QUALITY ASSURANCE -- NON-CONFORMANCE REPORT

Report No: NCR-000614

NCR #: ZPMC-0587

Reference Description: Welding was performed on Misaligned T-rib Stiffener to T-rib Stiffener splice joint at Segment 6AE/6BE

-The Side Panel (SP) weld joints are identified as:

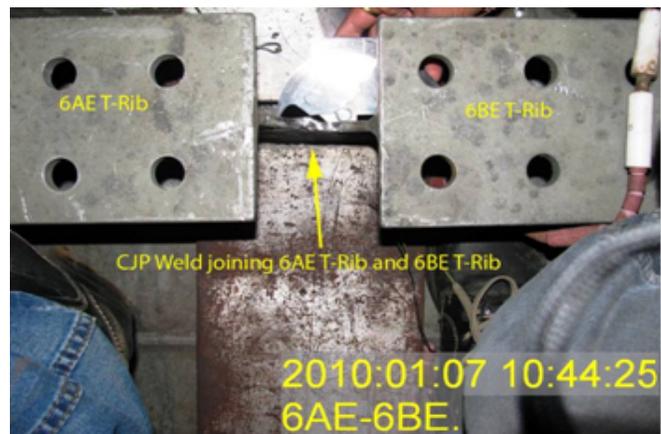
-Three (3) T-Rib web welds between the 6AE to 6BE (transverse splice) were misaligned across the weld joints.

- 1) SP307-001-032 (3rd T-Rib on SP from top-BP side)
- 2) SP334-001-023 (12th T-Rib on SP from top-BP side)
- 3) SP526-002-070 (1st T-Rib on SP from top-CB side)

-These welds are complete joint penetration (CJP) butt weld.

-The out of tolerance offset measurement across the welds were measured at 4mm.

-The maximum out of tolerance allowed per AWS D1.5 2002 is 3mm.

-Special Provisions Section 10-1.59 Steel Structures, Shop Welding G item 2: Misalignment between discontinuous members shall not exceed 10% of the thickness of the thinner member or 3mm, whichever is less.

-AWS D1.5 (02) Section 3.3.3: "Parts to be joined by groove welds shall be carefully aligned. Where the parts are effectively restrained against bending due to eccentricity in alignment, the offset from theoretical alignment shall not exceed 10 percent of the thickness of the thinner part joined, but in no case shall be more than 3 mm (1/8)."

Reference Resolution: ZPMC has cut the misaligned welds out and has realigned them. This correct alignment has been verified by the Department and this item has been removed from the punchlist to verify this.

ZPMC has cut the misaligned welds out and has realigned them. This correct alignment has been verified by the Department and this item has been removed from the punchlist to verify this. ZPMC is providing NDT documentation to show that the welds that were cut and rewelded are acceptable. Based on this ZPMC request closure of this NCR.

This proposed resolution is acceptable. The documentation received is sufficient and the Department concurs that Non-Conformance ZPMC-0587 is closed.

ZPMC has cut off these three ribs to rectify the flatness issue. ZPMC is providing NDT records show after rectification these split welds and affected fillet welds were tested acceptable. Please be noticed the weld ID SP526-002-070 was confirmed to be SP527-001-051. After NDT verification this issue has been removed from punchlist by CT's representative. Based on this, ZPMC is requesting this NCR to be closed.
